Access Compliance Report

Public Rights-of-Way

Intersection ID: 10018398	Main Street: CRANBOURN_CT	Cross Street: N/A	Location:	N
ADA ID: 28C2816FD9B5	Ramp Type: Perp	Initial Pass/Fail: Pass	Overall Compliance: No	Severity Score: 5

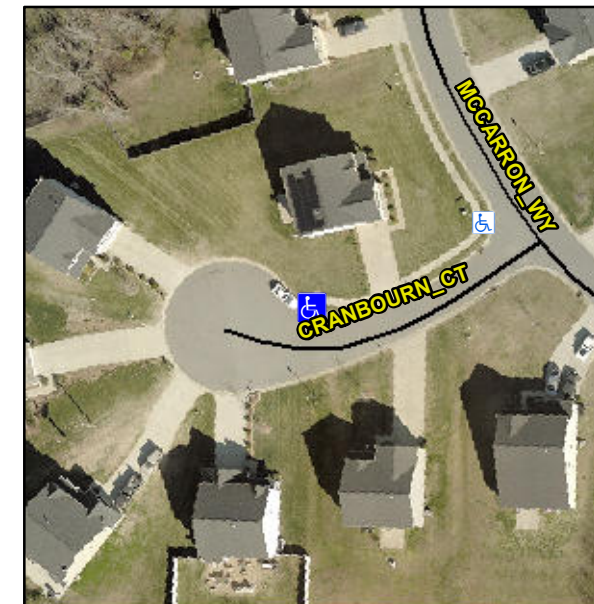
**Not Found, R304.2.1, R302.7,
R304.5.4**

**Remove & Replace Entire Ramp.
Remove & Replace Gutter.**
